ADDENDUM No. 1
2022 ROAD IMPROVEMENT PROGRAM

CITY OF OREGON
DEPARTMENT OF PUBLIC SERVICE

2) Change of Project Descriptions

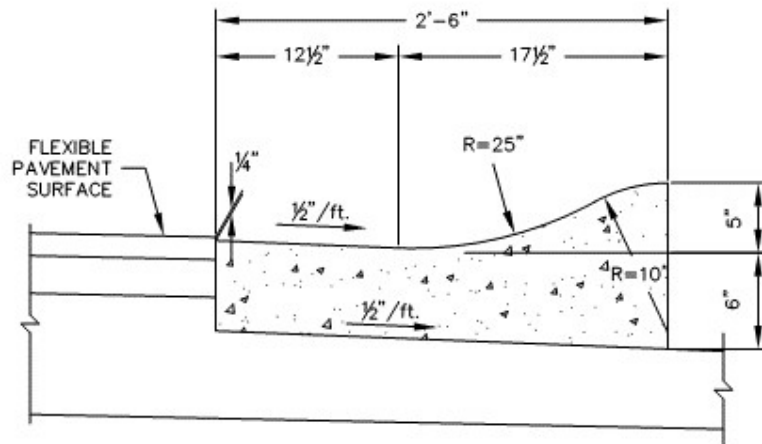
In paragraph one of "STAGE 2" of "CONSTRUCTION SEQUENCING" for Projects #2, #3, and #4, delete "Contractor shall excavate, form and pour the curb with MS concrete all within the same day." and insert "**Access to driveways shall be maintained until the afternoon the day before curb is poured. Access shall be restored once MS curb has cured.**"
